PRROW20251634

MEEKER FESTIVAL STREET  
PUYALLUP, WASHINGTON

SITE AND  
EXPLORATION PLAN

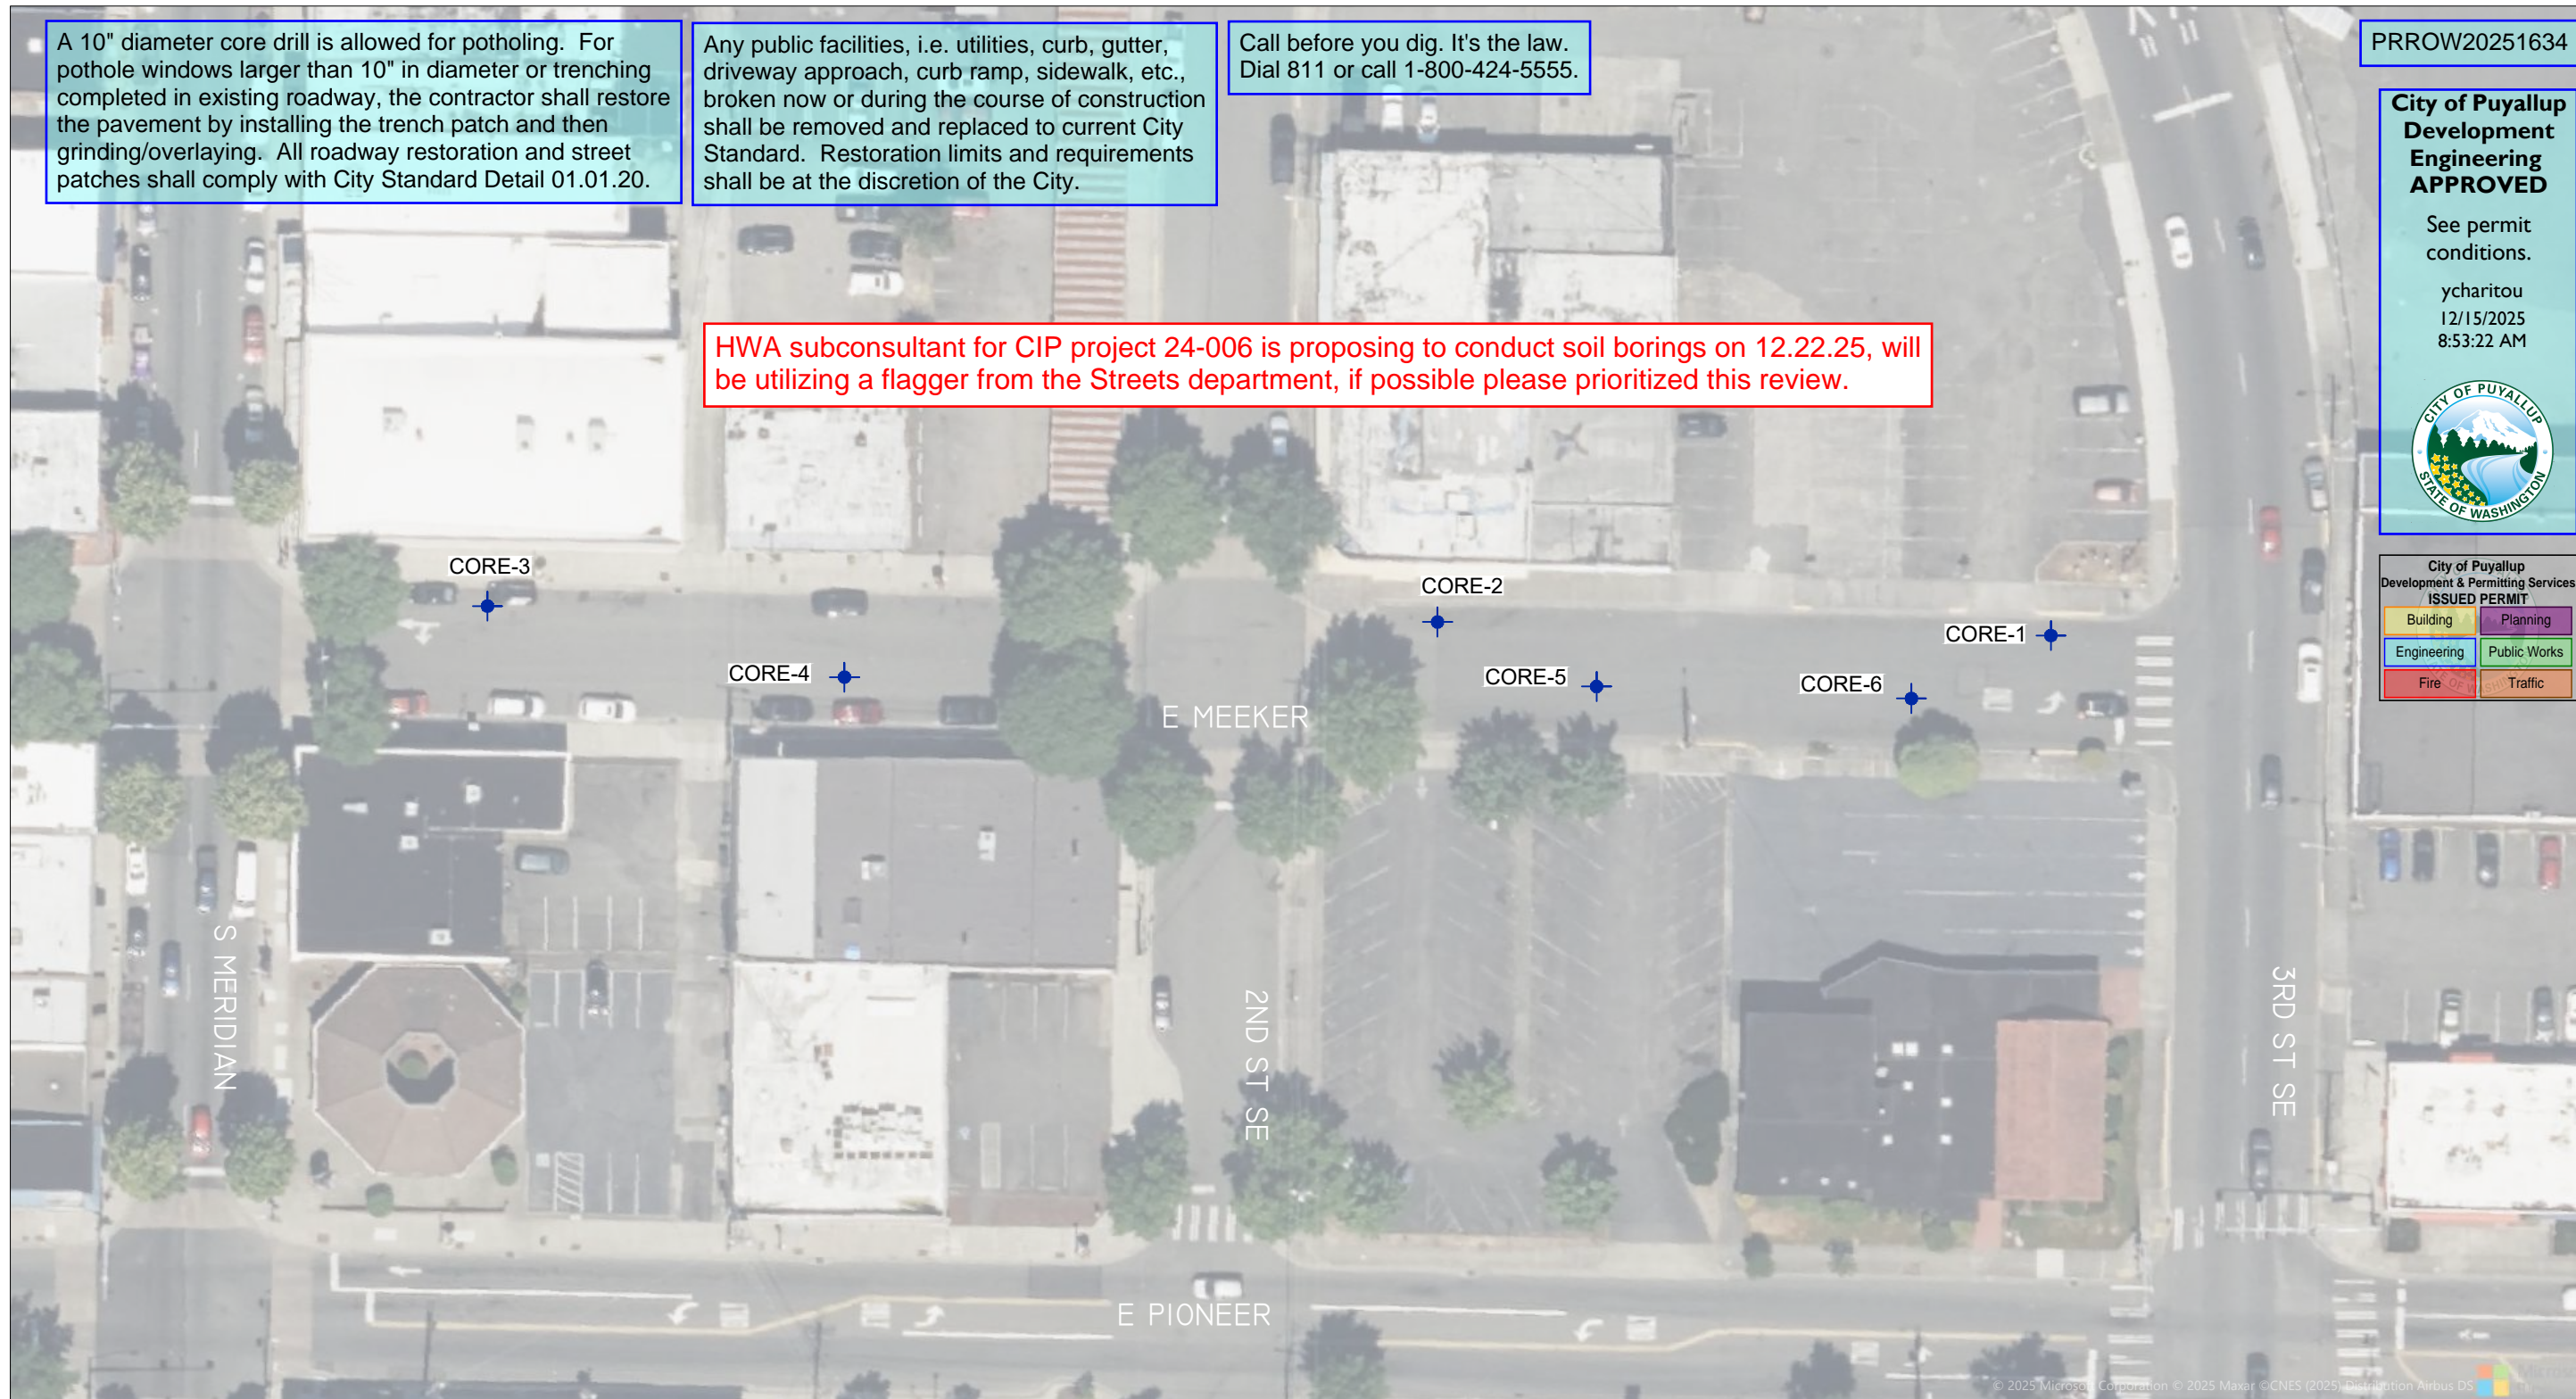
A 10" diameter core drill is allowed for potholing. For pothole windows larger than 10" in diameter or trenching completed in existing roadway, the contractor shall restore the pavement by installing the trench patch and then grinding/overlaying. All roadway restoration and street patches shall comply with City Standard Detail 01.01.20.

Any public facilities, i.e. utilities, curb, gutter, driveway approach, curb ramp, sidewalk, etc., broken now or during the course of construction shall be removed and replaced to current City Standard. Restoration limits and requirements shall be at the discretion of the City.

See permit conditions.

Cores will be approximately 6" in diameter and approximately 10-15' deep to investigate the existing roadway profile for future design of the festival street. Considering the roadway will be re-constructed in 2027, CIP Engineering is allowing the contractor to backfill the holes with the original material and patch them with Aquaphalt water-activated cold patch (preferred option), or quick-set concrete

**City of Puyallup  
Development  
Engineering  
APPROVED**
